Regular Meeting of Tuesday, October 7, 2025 at 3:00 PM
4th Floor City Hall Common Room

**PROJECT NARRATIVE
PARKING IMPROVEMENTS
FIVE STAR MITSUBISHI
PROJECT NUMBER 1451-2
SEPTEMBER 2025**

RE: Five Star Mitsubishi Rear Parking Lot
1200 Logan Boulevard
Land Development Review

**RE: FINAL LAND DEVELOPMENT PLAN - PARKING IMPROVEMENTS
FIVE STAR MITSUBISHI ALTOONA
CITY OF ALTOONA, BLAIR COUNTY**

SITE PLAN

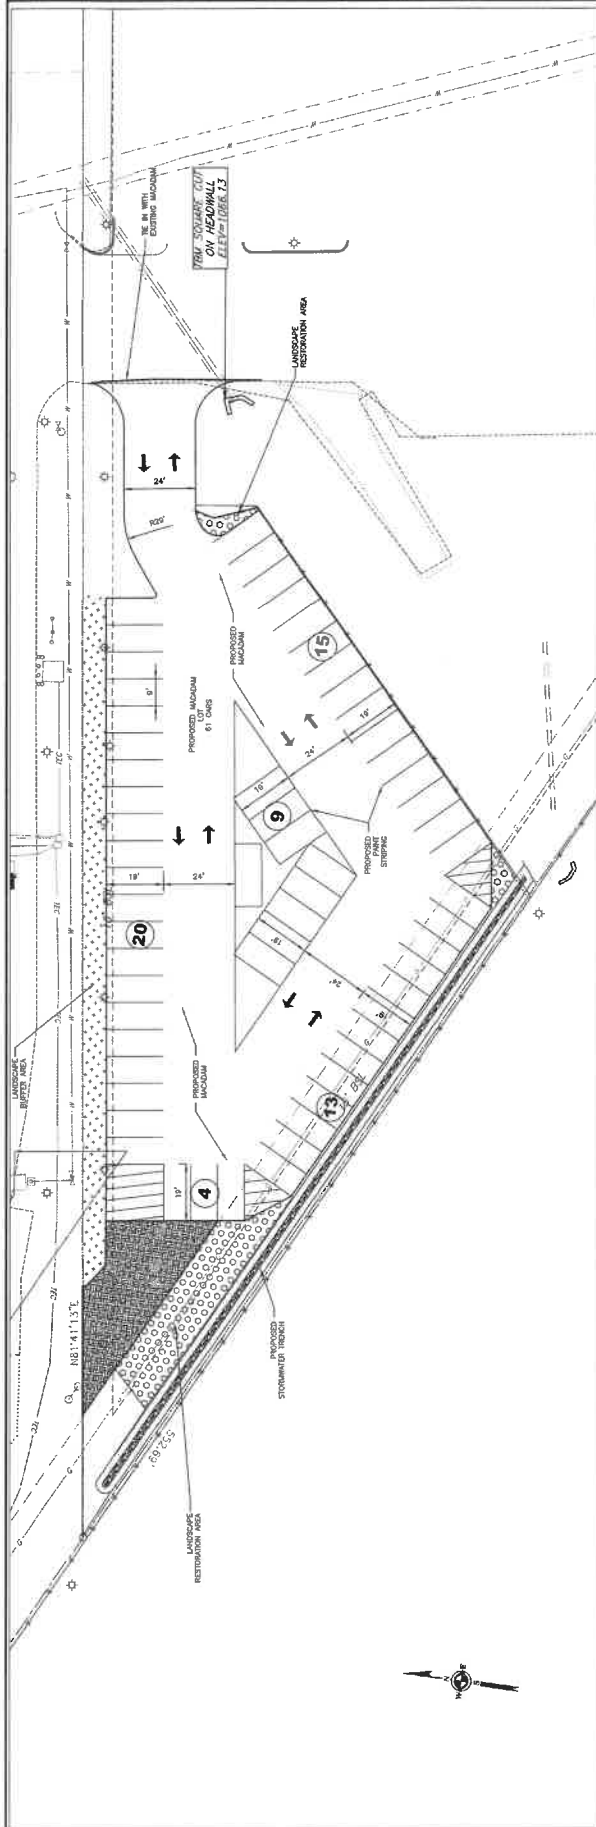
17. 640-57.H Provide proof of review and approval (for the Land Development Plan) from the County Planning Commission upon receipt.
18. 640-63.C(1) Facilities shall be designed so that each vehicle may enter and exit a parking space without maneuvering into a public right-of-way or pedestrian facility or without moving any other legally parked vehicle. The line striping in the upper left appears to have a spot for a vehicle to park diagonally. The adjacent vehicles would block this space in. While the City has no objection for Five Star to park a vehicle there if the lot is only for vehicle inventory, it should be hatched off and not an "official parking space"

19. 640-63.C(3a) Parallel parking stalls shall be 21 feet long to accommodate the necessary maneuvering for parallel parking.
20. 640-63.C(7) Curbing shall be placed at the edges of all surfaced areas, including islands. Curbing shall be vertical around the perimeters of the parking facility but may be sloped around landscaped islands. A waiver has been requested to provide no curbing indicating that the lot is for inventory and not public parking.

22. 640-65.E.3. Where a parking space abuts any element of the parking or loading facility except the access drive directly servicing the space or another parking space, an island shall be installed to protect the parked vehicle from the moving vehicles and to provide definition to traffic patterns. A waiver has been requested to not provide islands at the ends of parking indicating that the lot is for inventory and not public parking.

17. The BCPC review will be provided upon receipt.
18. This is a vehicle inventory lot. The area in question has been striped off.
19. The one parallel "stall" was made 21' long even though this is only an inventory storage lot.
20. No response necessary.
21. The waiver request has been amended to include this section of the ordinance. A revised waiver request list is enclosed.
22. Any lighting is existing and is not being touched with the design. The existing area is highly industrialized and commercialized.

INFILTRATION TRENCH

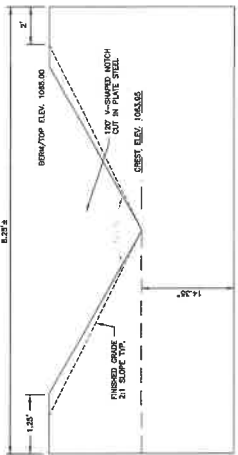
- The plans call out a swale; however, the calculations appear to route a detention facility with a flat bottom and ponding. Please provide enough detail to assure intended construction, including elevations.

10. See response 9 above.
11. A. The references to 'swale' have been changed to 'trench', and a table with elevations has been added to the trench detail.
